INDESIT company

Model type:
WP100EX

Commercial code:
F027761

FIG. 1

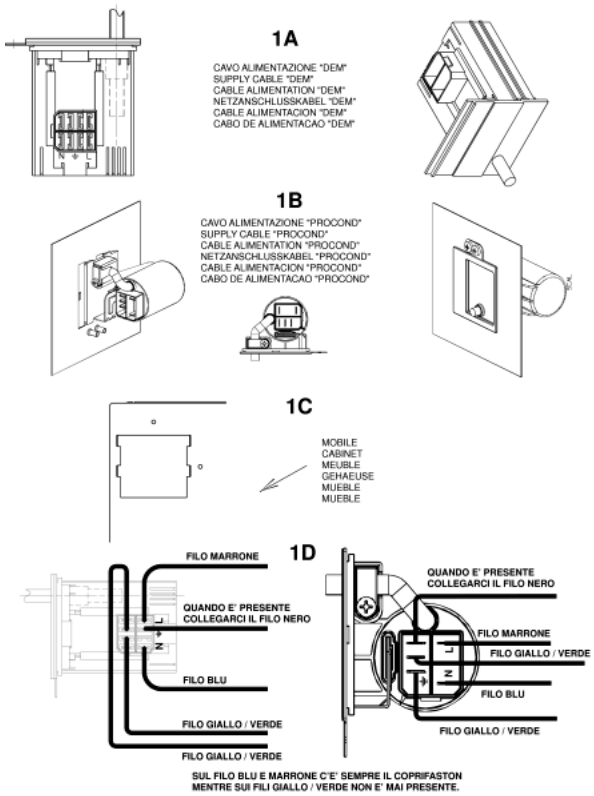
n1040276: Power supply cable + integrally moulded filter.

All appliances produced in the Comunanza (from serial no. 21008.0001), Teverola (from serial no. 21111.0001) and Brembate (from serial no. 21119.0001) factories have been equipped with power supply cables with integrally moulded filter (see fig.1 - 1A and 1B) and new units having a specific opening at the back for fixing the new cables (see fig. 1 - 1C).
The new units, together with the new cables, can be used in place of the premodification ones, by connecting the wiring to the cable, as shown in figure 1 - 1D.
The codes of the new units and of those replaced (ESI - table n1040276fig02), which will be managed until stocks run out, are given below.

The new power supply cables are:
Code 091632 - Power supply cable 3x1 schuko 1.5m+capacitance filter;
Code 091633 - Power supply cable 3x1 schuko 1.5m+inductive filter;
Code 091634 - Power supply cable UK 3x1 l= 1950mm + inductive filter;
Code 091635 - Power supply cable UK 3x1 l=1950mm+capacitance filter;
Code 091636 - Power supply cable l=2.55m AUS+inductive filter;
Code 091641 - Power supply cable l=2550mm AG +capacitance filter;
Code 091642 - Power supply cable 1.85mt SHUKO no inductive filter;
Code 091643 - Power supply cable 3x1 (CH) 1.5m+inductive filter;
Code 091645 - Power supply cable 3450mm SOUTH AF.+capacitance filter;
Code 091690 - Power supply cable shuko l2.55m KOREA+inductive filter;
Code 091689 - Power Supply cable l=2550mm AG+inductive filter.

IMPORTANT: the fixing / continuity screw is a specific self-scraping screw (code 092348) that ensures earth continuity between the filter and the unit. The same screw must be refitted in order to guarantee machine conformity.

The premodification wirings, are also managed for modified products by making the connection to the terminal block of the new cable as shown in fig. 1 - 1D.
The wiring diagrams given in the Documentation remain unchanged.

Insieme nuovo fissaggio del contrappeso.

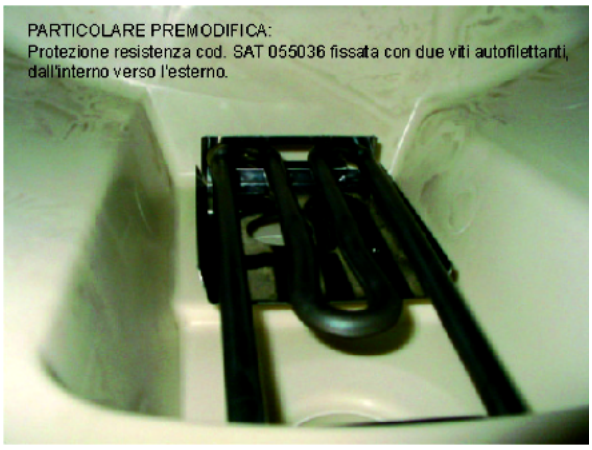
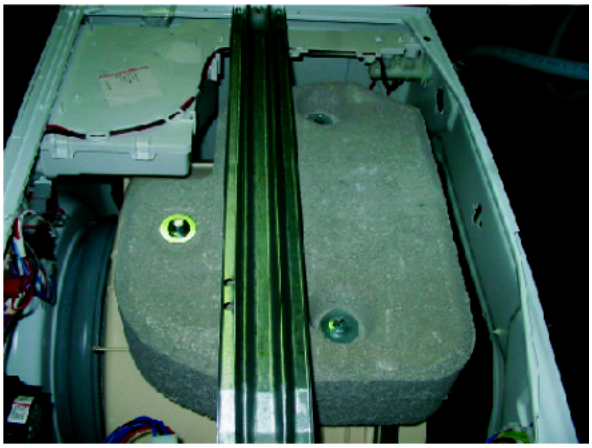
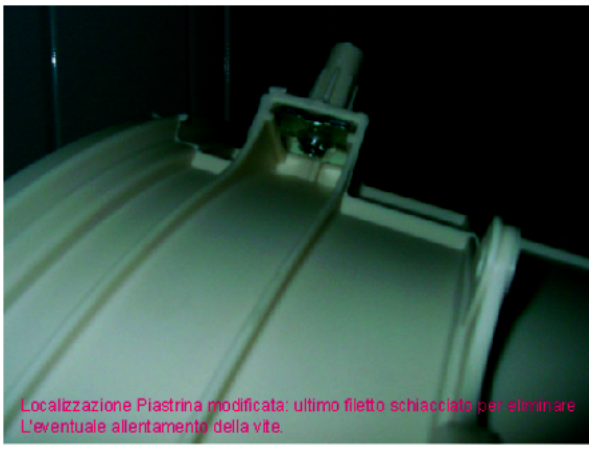
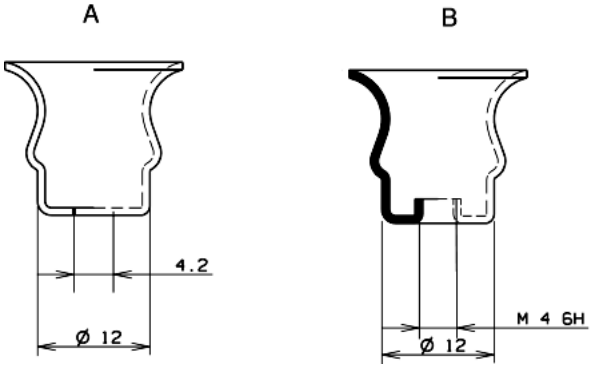
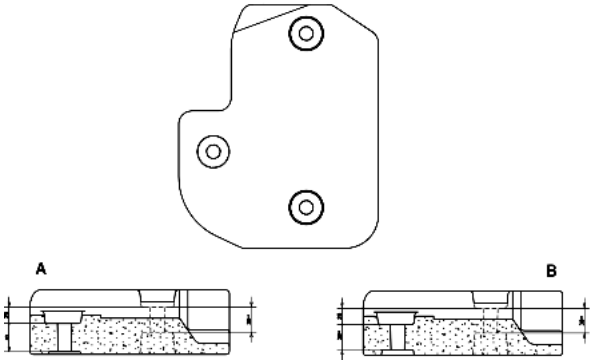
n1040279: Heater retaining element bracket and counterweight fixing

From serial no. 21015.001, a heater retaining element bracket (see fig.3) has replaced the heater retaining element protection Sat code 055036 (see fig.4) on all plastic tanks installed in washing machines produced in the Teverola factory.

The new part (fig. 1A) is fixed to the bowl with a self-tapping screw from the inside outwards and differs from the one used in the Comunanza factory (fig. 1B) in the fixing hole which is not threaded.
In order to reduce the number of parts used, only kit 058523 is managed and which, if used on the Teverola washing machines, must be fixed with a self-tapping screw, instead of metric, after widening the tapped hole with a suitable drill bit.
When inserting the heater retaining element, particular care must be taken so that it is fitted correctly (Fig. 3).
The plastic tanks to be arranged for the guide have the same Sat code as those with the protection.

>From serial no. 21121.0001, the counterweight Fig. 2B with outlet increased by 5 mm in the centre has replaced the previous counterweight Fig. 2A.
The new counterweight (fig. 5) is fixed using three M8 X 63 mm screws with washer code 092016 (see fig. 8) and three plates with the last thread flattened (fig. 6) to prevent accidental loosening of the screw.
All the plates code 055038 in stock in the Centralised Warehouse have been replaced and can also be used on premodification appliances.
The modified counterweight has the same Sat code as the premodification item (066615) that will be managed until stocks run out.
The new counterweight must be assembled using the new screws and plates (see fig. 7).
Both counterweights can be employed necessarily using the following fixing parts which are specific for each type of counterweight:

Fixing parts for premodification counterweight (see fig. 9):
3 pieces code 055019 - Screw M8 X60 mm;
3 pieces code 055018 - Conical washer;
3 pieces code 034336 - Flat washer;

Fixing items for modified counterweight:
3 pieces code 092016 - Screw M8 X 63 mm with washer;
3 pieces code 055038 - Plate with last thread flattened;

FIG. n1040305fig01

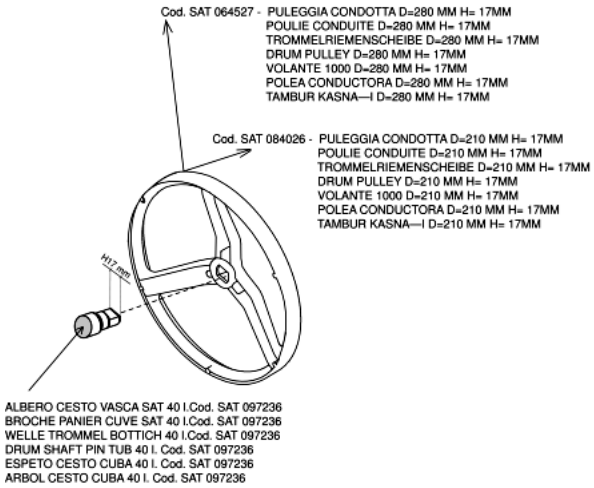
n1040305: Introduction of EVO on LB2000 washing machines produced at Teverola.

Since August 2003, the following modifications are gradually being made to the oscillating unit on 2000 range models produced in the Teverola factory:
Gradual use of the EVOII 40 litre plastic bowl (code 097236) which differs to the previous LB2000 version, for the following characteristics:
1) Assembled with basket and welded bowl lid;
2) Elimination of detergent recovery tube hole (where provided);
3) Diameter 30 cm opening instead of 28 cm;
The last two numbers of the Industrial Code (given on the rating plate) of the models relevant to this system will be 30 (e.g. 46268790030)
This modification has involved the use of a new table for the oscillating unit (1140240) in the documentation of the relevant models, and for the appliances the following parts have been used:

·Eeproms - The new software for the 40 litre EVO washing machines can also be used on premodification appliances; it is managed with the same Sat codes as the previous software, which is being immediately replaced as the new models enter into production.
·Pulleys - The use of a single 40 litre bowl assembly in Assistance involves management of the pulleys used in production (097268 and 097267) and also those required for creating the various combinations (see fig. n1040305fig.01):

Code 064527 - Pulley D=280mm H=17 mm;
Code 084026 - Pulley D=210mm H=17mm.

NB: From serial no. 31103.0001, all EVO appliances are equipped with a 40 litre bowl with H=15 mm drum cross shaft which will be managed with the same SAT code (097236) as the 40 litre bowl with H=17 mm shaft until stocks last.
To create the various combinations, the following pulleys are required:

Code 097268 - Pulley D=280mm H=15 mm;
Code 097267 - Pulley D=210mm H=15mm.
Exceptions to this are models W93UK (23330) and W103UK (23334) which are equipped with a 46 litre bowl; therefore if the bowl needs replacing code 096198 with 20 mm pulley cross shaft must be used.
In production, pulley code 064527 (diameter D= 280 mm and central hole H= 17mm) is used; therefore, when replacing the bowl, code 097269 (diameter D= 280 mm and central hole H= 20mm) must be used.
